Motorola

MoPar 900

MoPar 901

RESISTOR DIFFERENCE

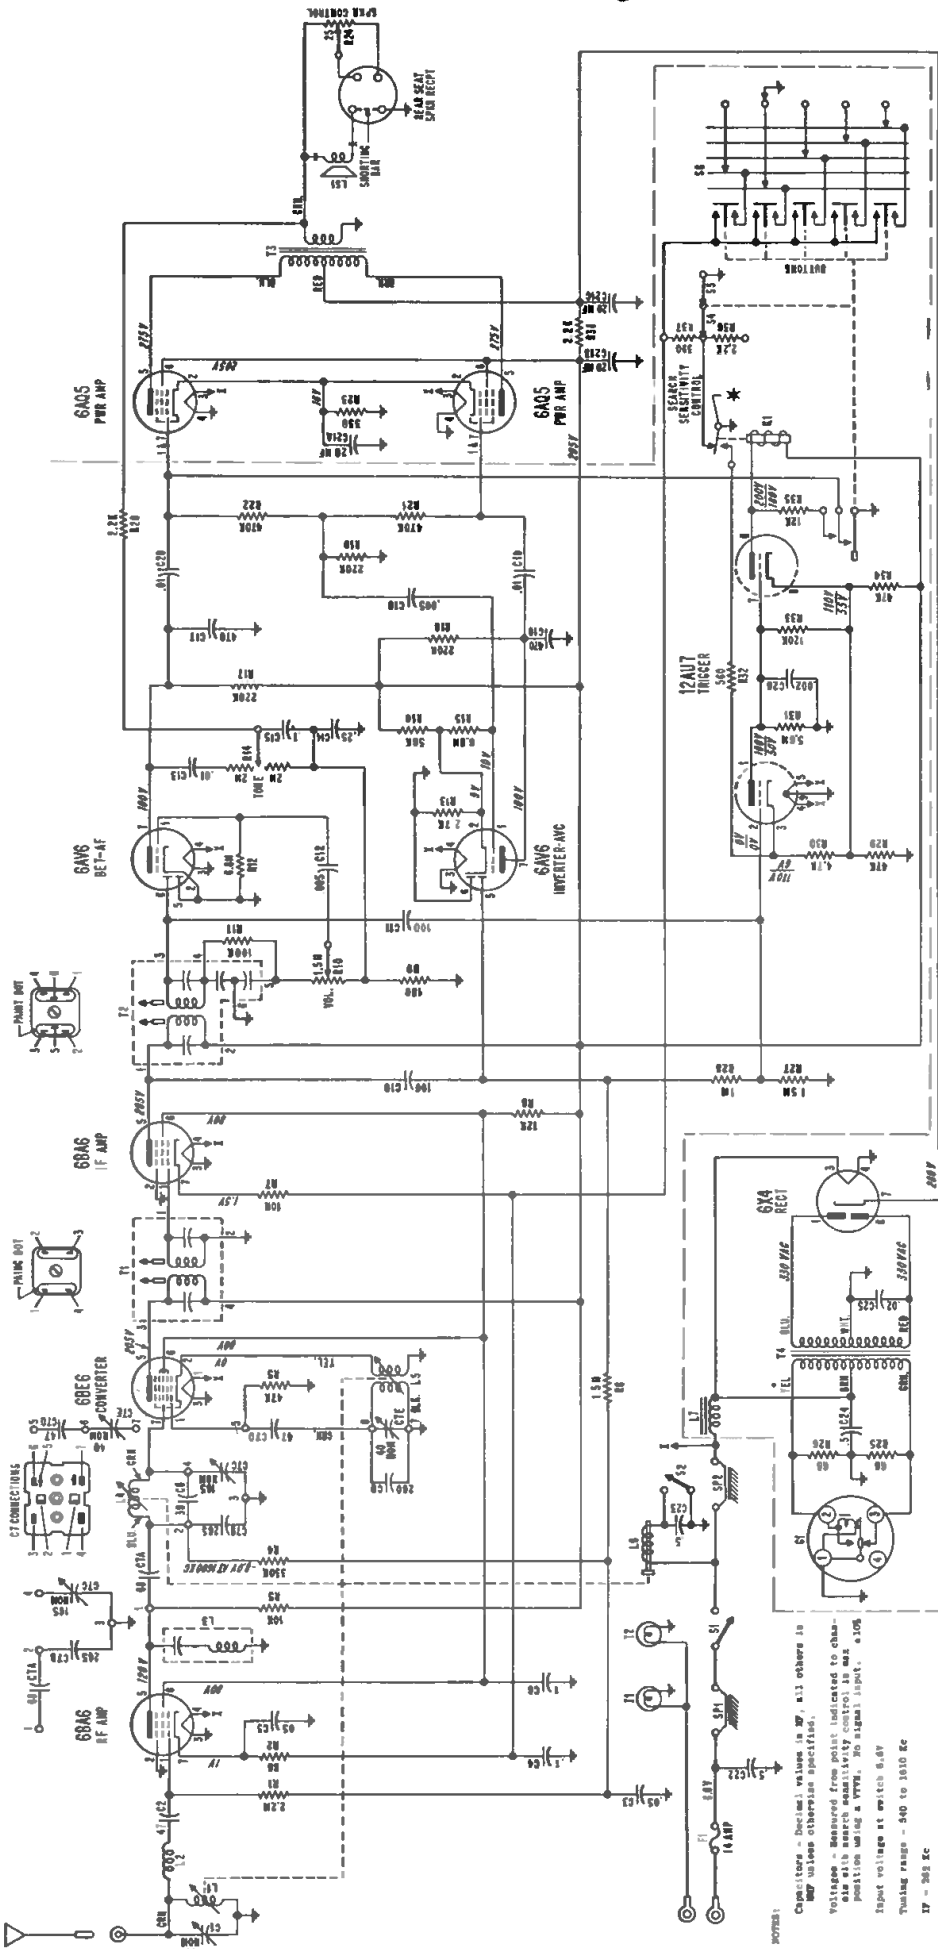
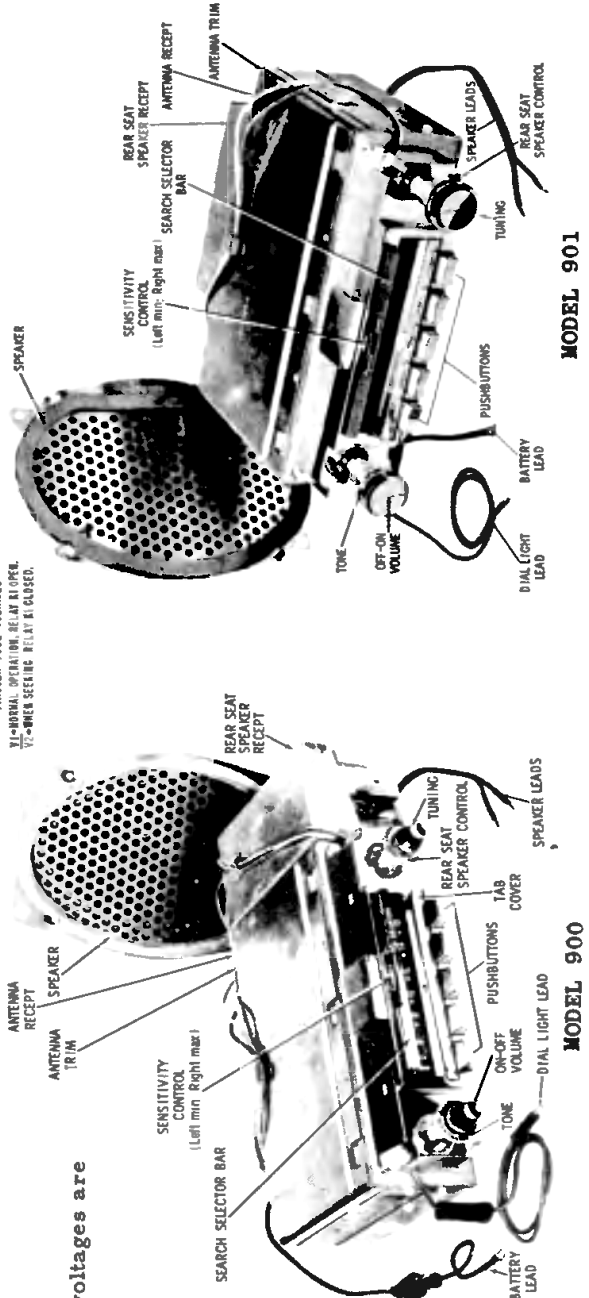
In some sets, the following resistors and voltages are used in place of those shown on schematic:

Resistors					
R-13	6R5581	3300	10%	1/2W	
R-30	6R490492	6800	20%	1W	
R-31	6R3988	3.3 meg	20%	1/2W	
R-32	6R6229	1000	10%	1/2W

Voltages					
6AV6	Inverter	pin 2	12 volts		
12AU7	Trigger	pin 1 & 7	100V	55V

pin 3 110V
7V

pin 8 100V
60V
